# FORESTSIDE TOWNHOUSES

## SITE INSTRUCTION # 5

JAP Project No: 19066

Issued for : ISSUED FOR SITE INSTRUCTION # 5

Job No: 19066 Sheet No: S-102A

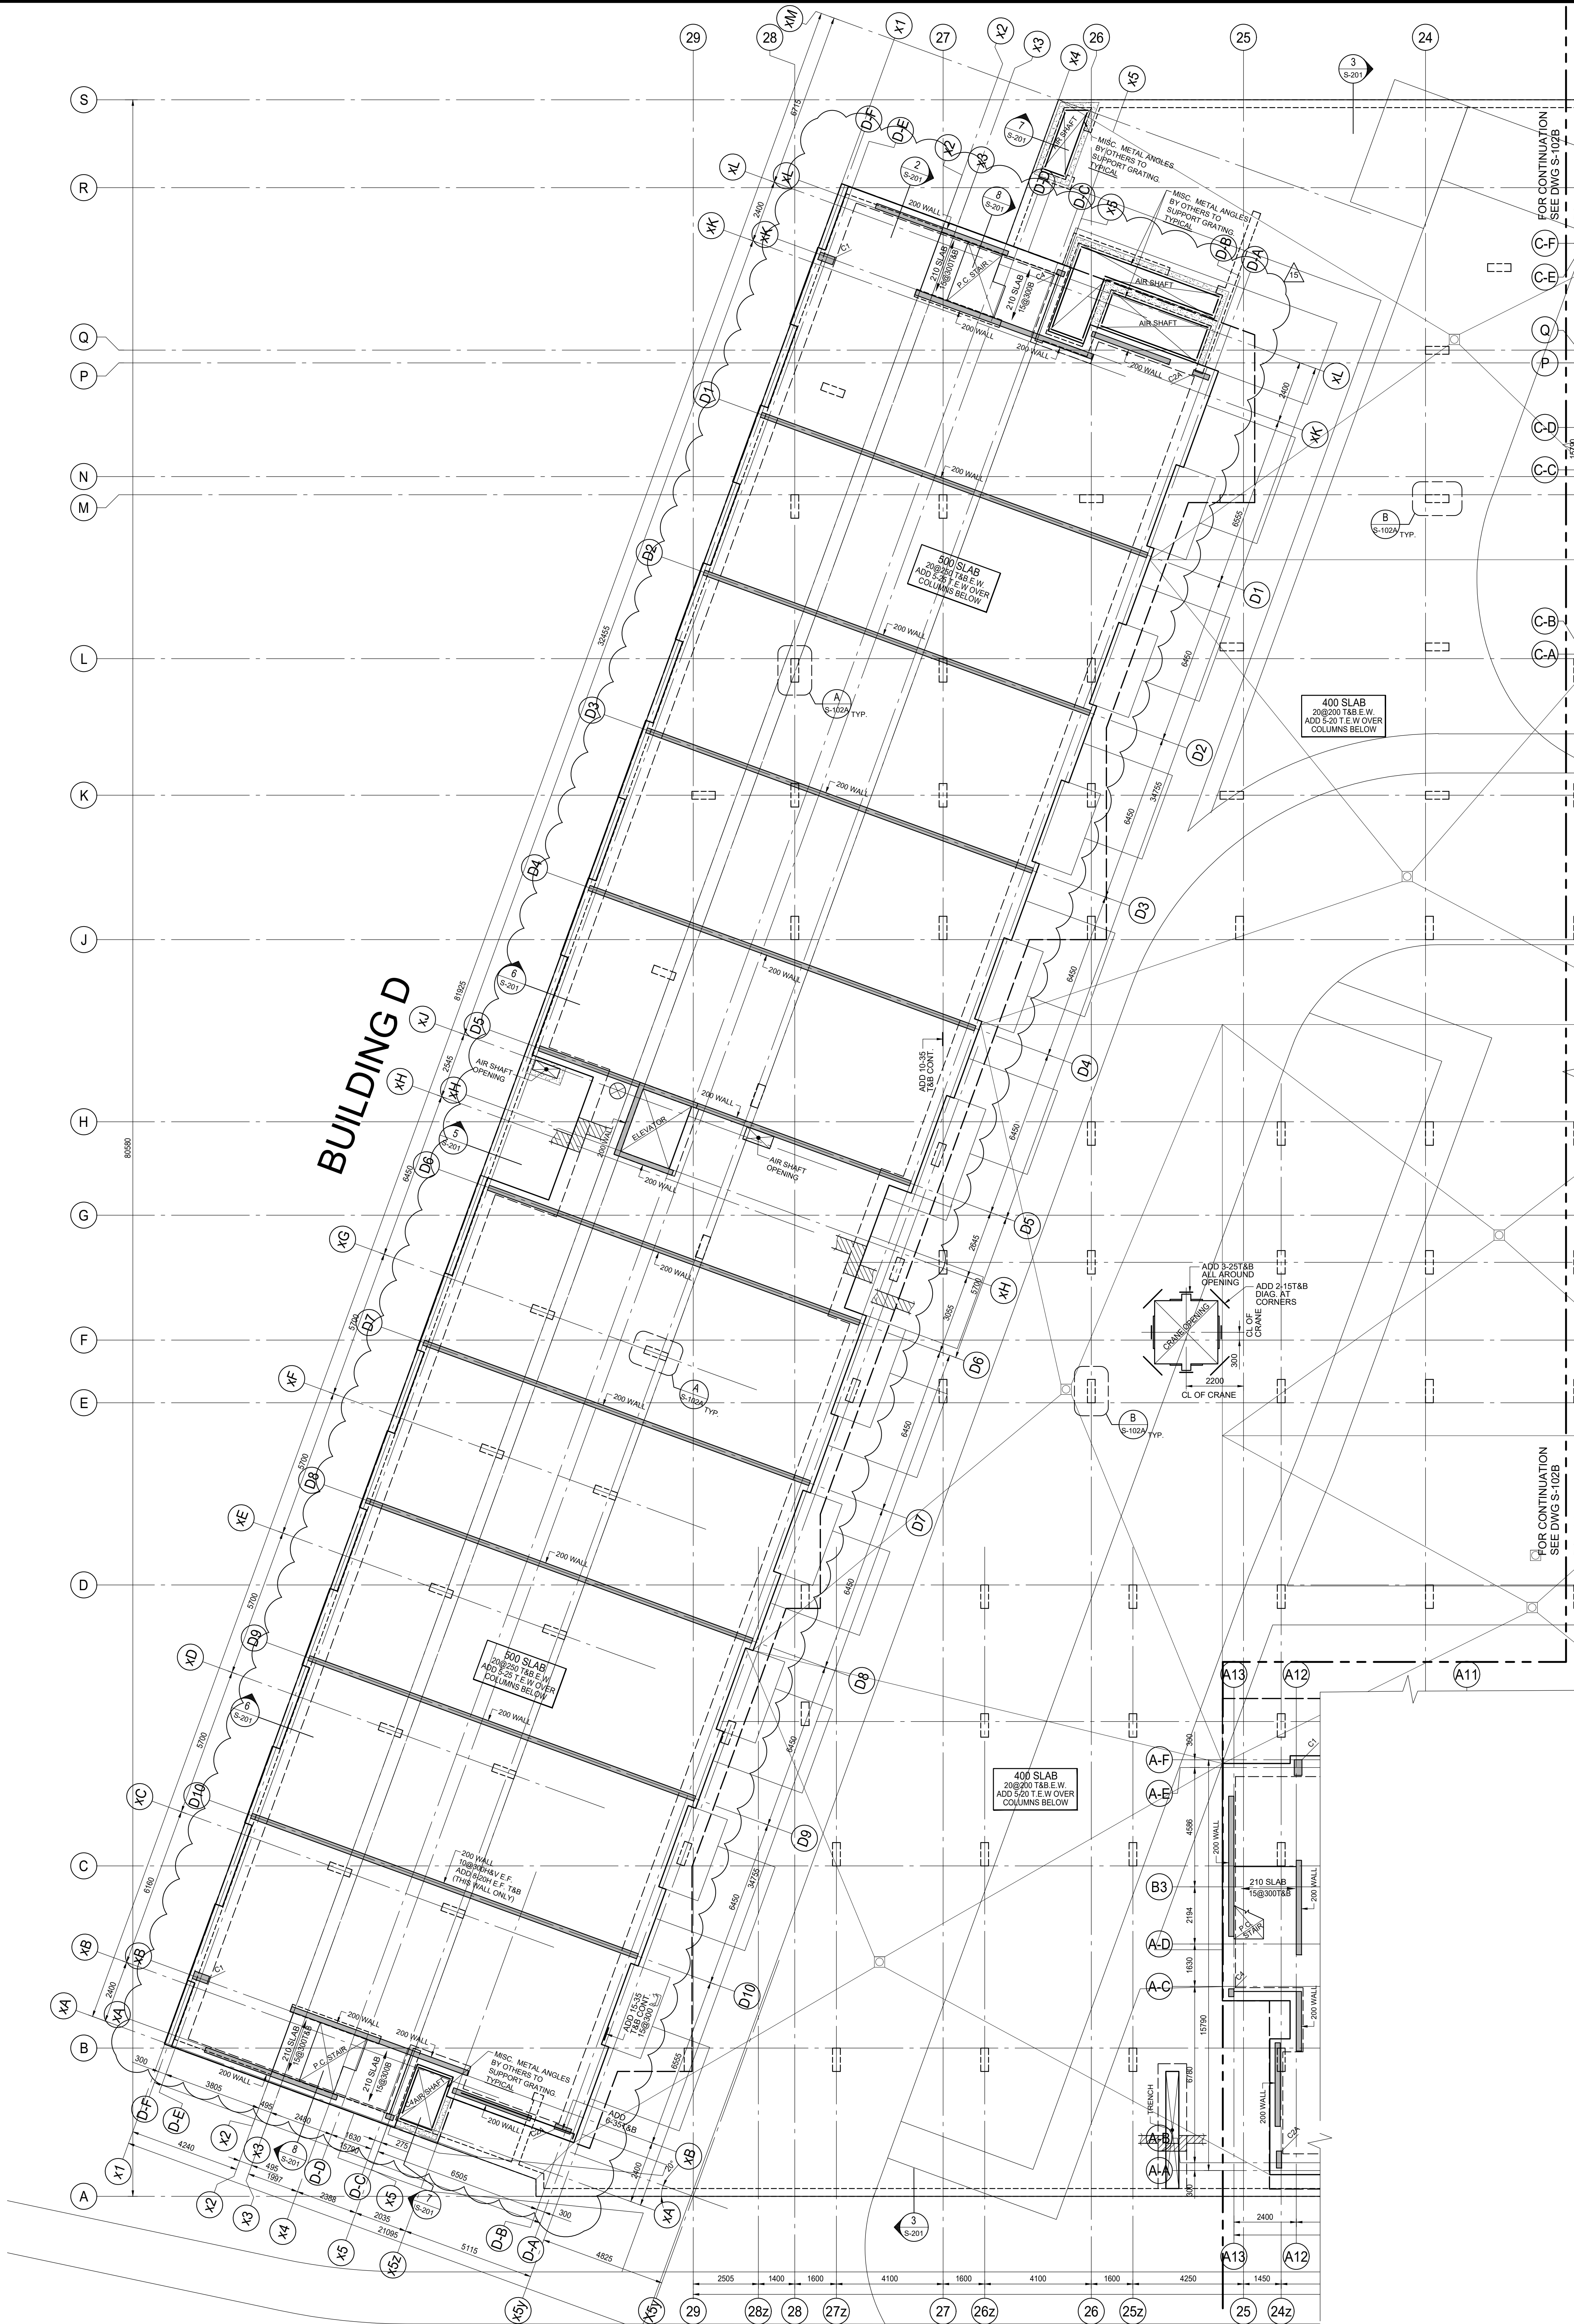
#### 1.1 Refer to Drawing S-102A & B "GROUND FLOOR FRAMING PLAN"

- a) Removed wood stairs on building D to 2<sup>nd</sup> floor
- b) Infilled wall openings on Building D
- c) Infilled wall openings on Building C
- d) Matching stair locations from latest architectural on Building C, Block 6

Job No: 19066 Sheet No: S-103A

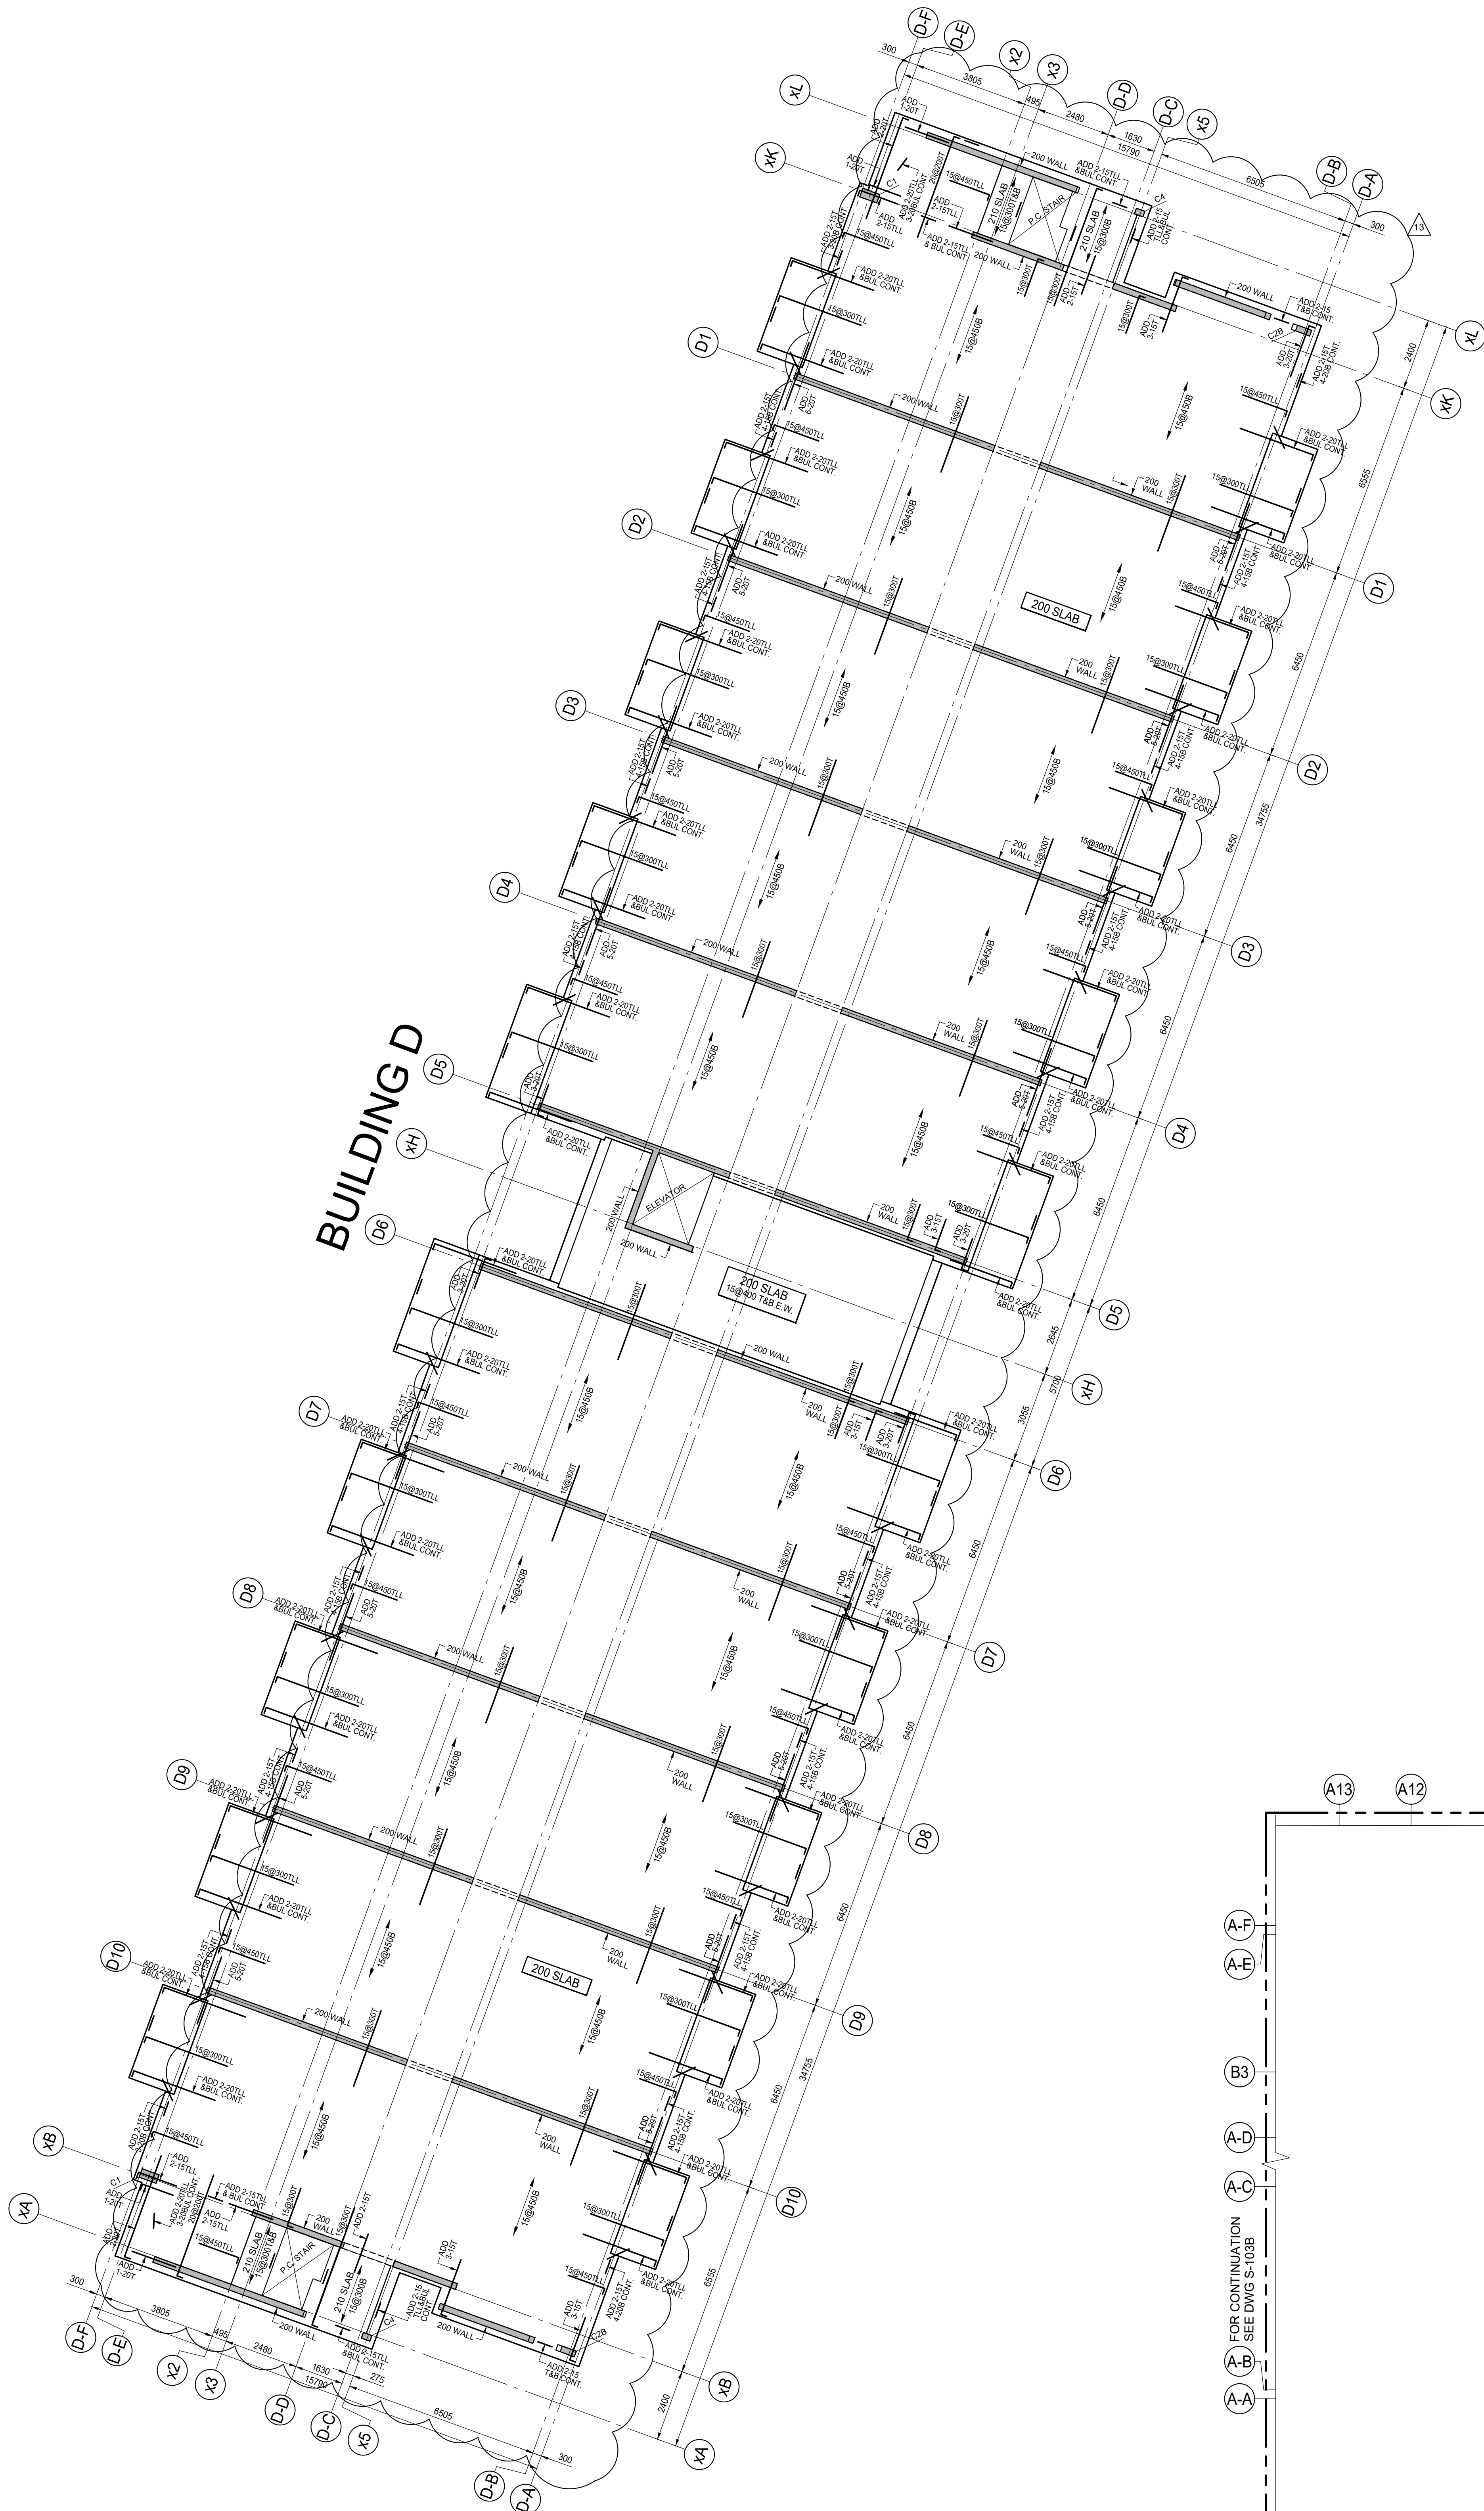
#### 1.2 Refer to Drawing S-103A & B "2ND FLOOR FRAMING PLAN"

- e) Updated to match slab edge to remove stair openings as bubbled on Building D
- f) Infilled wall openings on Building D to match latest architectural
- g) Match stair openings with slab edge on Building C, Block 6
- h) Infilled openings on Building B to match latest architectural
- i) Infilled openings on Building A to match latest architectural
- j) Deleted balconies on rear of Building C to match architectural
